September 22, 2023
AVO 37449

Ms. Ramie Hammonds
Development Services Director/Building Official
City of Sanger
201 Bolivar Street
P.O. Box 1729
Sanger, Texas 76266

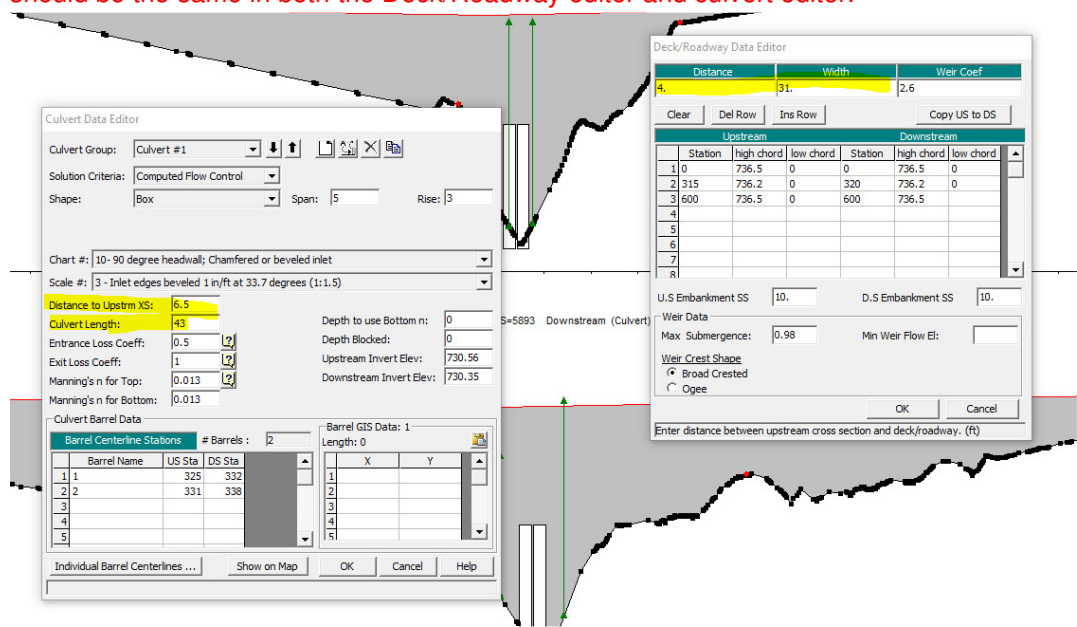
4th Review Comment: Please address comment on Sheet 12-8 Addressed

11. Provide RAS model for all proposed roadside ditches (Criteria Manual Section IV.3.4) including Sam Bass Road. Include proposed culverts and driveway culverts and verify the 100-yr fully developed flow is contained within the right of way. If not contained within ROW, additional DE must be dedicated to contain the fully developed 100-yr water surface elevation.
1st Review Response: HEC RAS model included for channels, roadside ditch and culverts
2nd Review Comment: Noted.

12. Please ensure side yard swales contain the 100yr WSEL and do not drain to the adjacent lots. Provide a typical section with hydraulic parameters. Ensure the typical section is feasible in each of the lots according to the grading plan.
1st Review Response: side ditch sized to contain 100 yr discharge
2nd Review Comment: Address side yard swales comment on grading sheets (sheet 8)
2nd Review Response:
3rd Review Comment: Addressed.

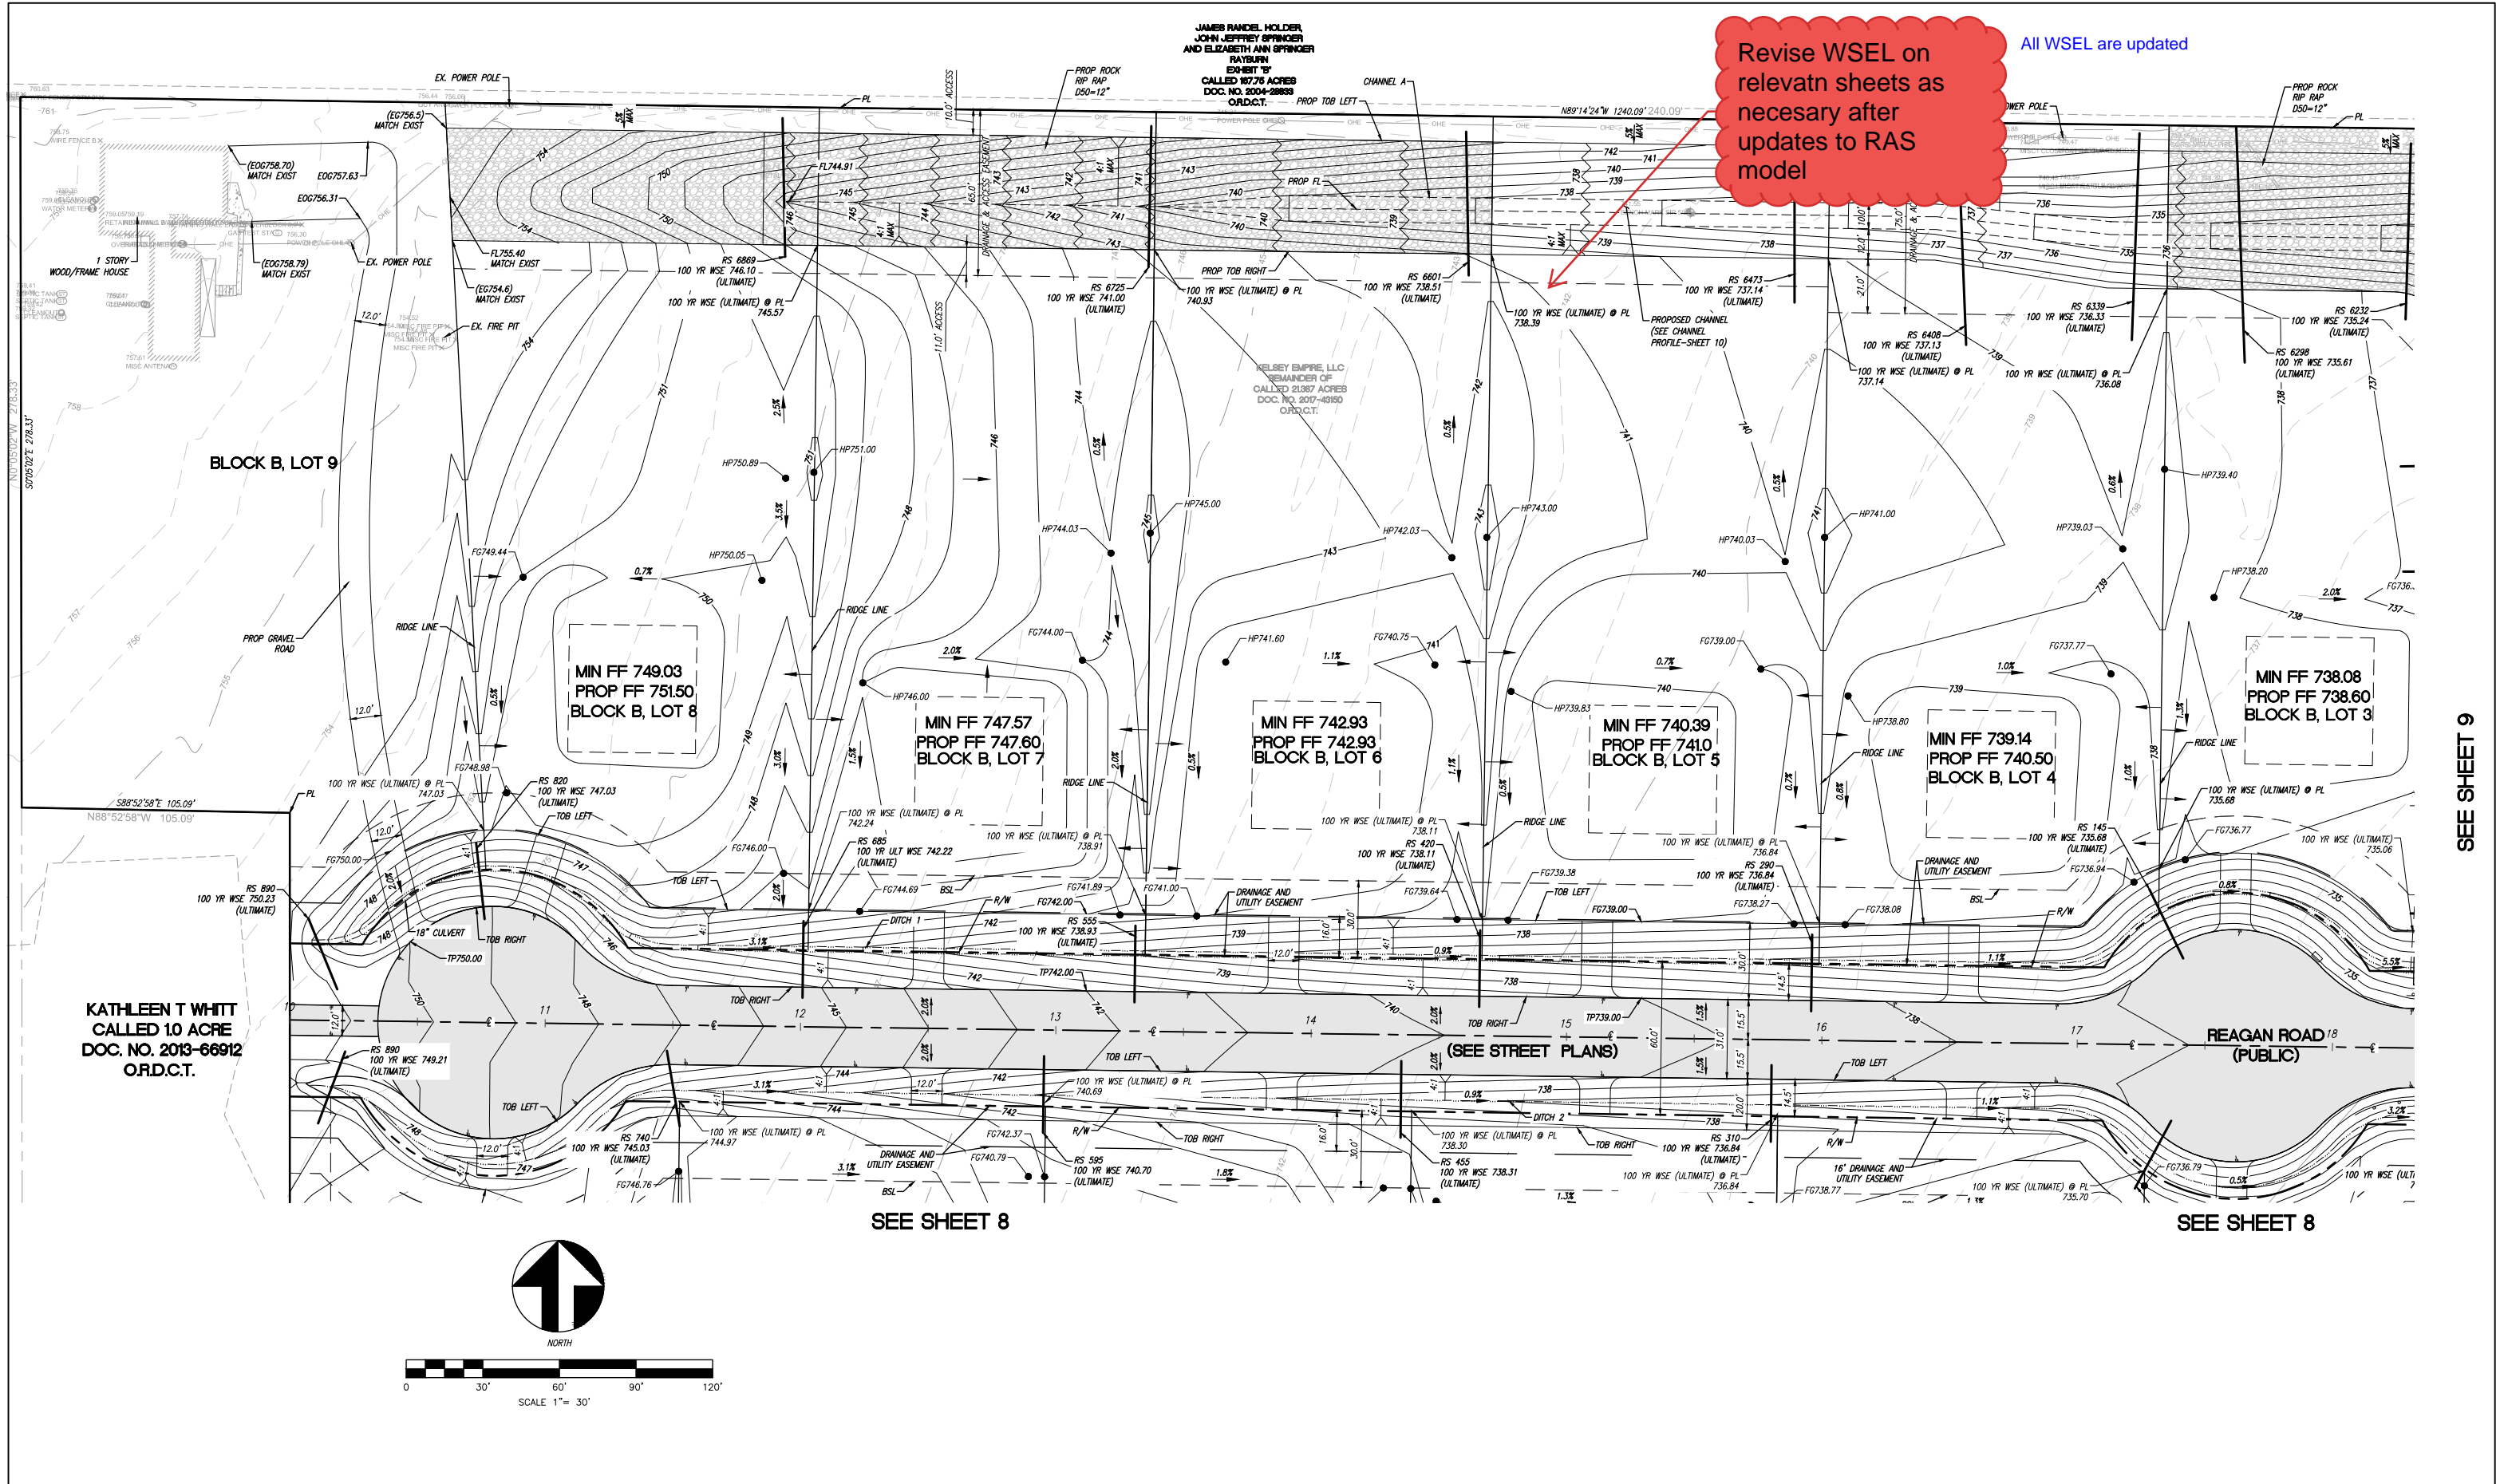
- Plan Markups

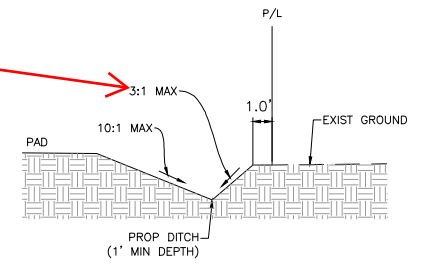
Revised to 4:1 max slope
